**GOVERNMENT OF THE DISTRICT OF COLUMBIA**  
**DEPARTMENT OF TRANSPORTATION**

**MEMORANDUM**

**SUBJECT:** **Zoning Commission Case No. 15-02 – Brookland Townhomes Supplemental Report**

Figure 1. Updated Site Plan (Source: Applicant)

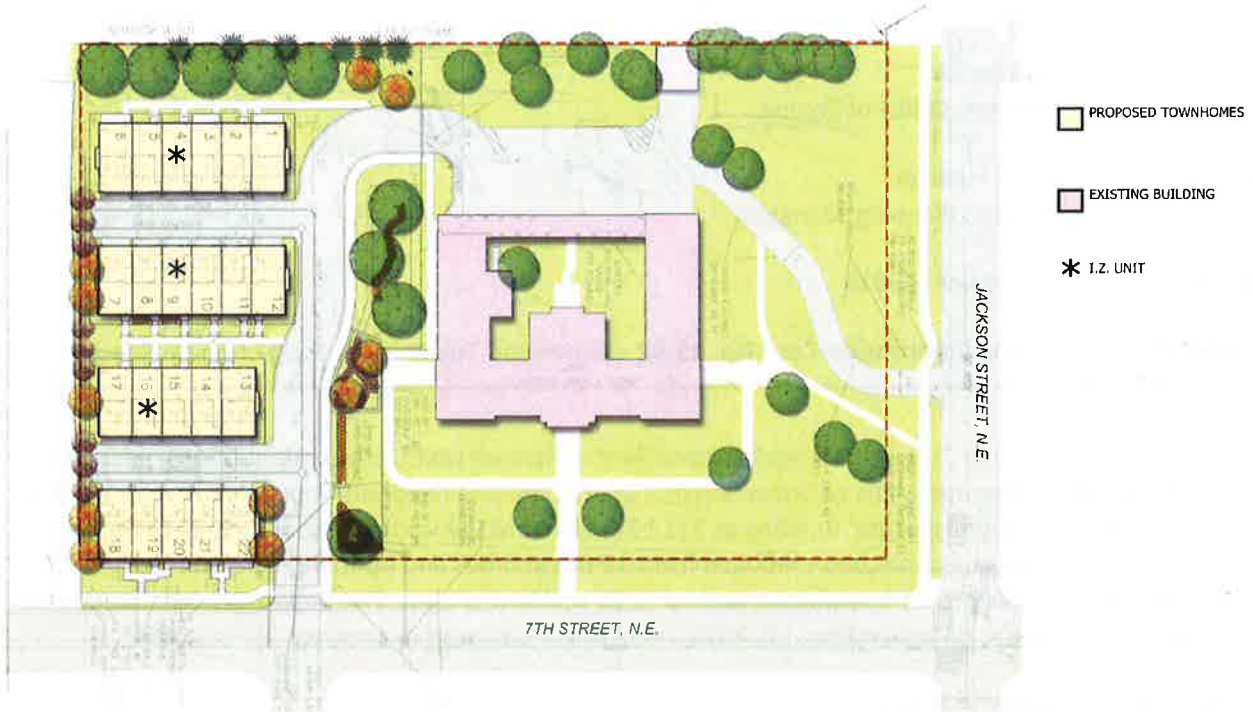
Vehicular access will continue to occur via driveways from 7<sup>th</sup> Street and from Jackson Street, but the Jackson Street entrance is modified from the prior plan. The 7<sup>th</sup> Street entrance remains unchanged from the prior proposal. Small private alleys are proposed behind the townhomes providing access to the vehicular parking spaces. The existing lot behind the Redemptorists' Building with 23 spaces will remain and one-way southbound access to this lot is proposed. Thus, access to the lot will be from the Jackson Street driveway only, and the Jackson entrance now partially utilizes an existing driveway on the site. Any loading access would also occur via these driveways. Two curb cuts for this project remains appropriate.

DDOT is continuing to work with the Applicant on the Jackson driveway entrance design to run the requisite AutoTurn analyses, to minimize impacts to onsite as well as street trees, consider stormwater impacts, and to provide as straight an alignment as possible, ensuring a safe design. It is important to DDOT that the driveway provides perpendicular access at Jackson, and direct and predictable access to the property. It is anticipated that the Applicant will continue to work with DDOT during the public space permitting process to finalize the entrance and driveway design, which may further modify this proposed entrance.
